Project	IEEE 802.16 Broadband Wireless Access Working Group < http://ieee802.org/16 >	
Title	Relay zone structure definition	
Date Submitted	2007-01-08	
Source(s)	Mike Hart Fujitsu Laboratories of Europe Ltd. Hayes Park Central Hayes, Middx, UB4 8FE, UK	Voice: +44 20 8606 4523 Fax: +44 20 8606 4539 mike.hart@uk.fujitsu.com
Re:	Call for technical proposals 802.16j-06/034	
Abstract	This contribution provides a text proposal that defines the structure of the relay zone in the downlink subframe. This builds on the current frame structure text accepted in meeting #46 that introduce the concept of a relay zone within a subframe, but did not provide a definition of the structure of the relay zone in the downlink. In summary the proposed structure is very similar to that employed by a MR-BS (or BS) in the access downlink link zone.	
Purpose	For discussion and approval of inclusion of the proposed text into the P802.16j baseline document.

Relay zone structure definition

Figure xxx – Structure of the first relay zone in the downlink.

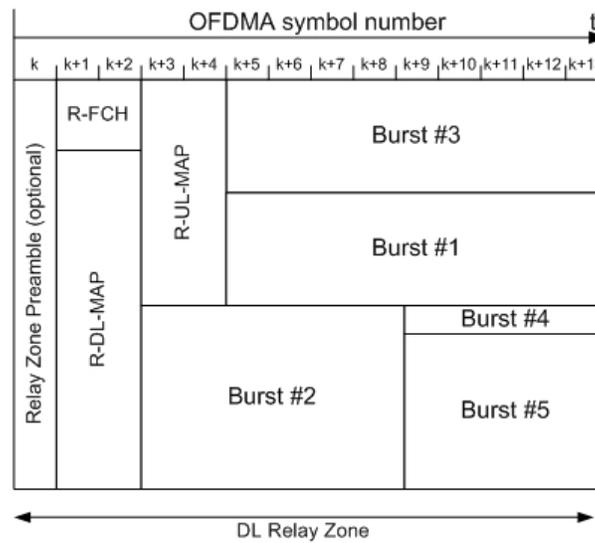
Figure xxx in the following section depicts the proposed structure for the relay zone in the downlink. As shown it contains an optional relay zone preamble [5], followed by a mandatory R-FCH, R-DL-MAP and optional R-UL-MAP message. This is followed by the data bursts.

The first relay zone in the downlink subframe shall contain the information that defines the structure of all relay zones in a frame. The first relay zone may start with a zone start preamble, followed by a mandatory R-FCH. If the zone start preamble is absent then the first relay zone shall start with the mandatory R-FCH. The R-FCH contains the DL Frame Prefix described in Section 8.4.4.3, and specifies the length of the mandatory R-DL-MAP message that immediately follows the DL Frame Prefix and the coding used for the R-DL-MAP message. The R-DL-MAP message may be followed by an R-UL-MAP message. The R-FCH and R-MAP messages shall be transmitted in a PUSC zone. The structure of the first relay zone in the downlink is illustrated in Figure xxx.
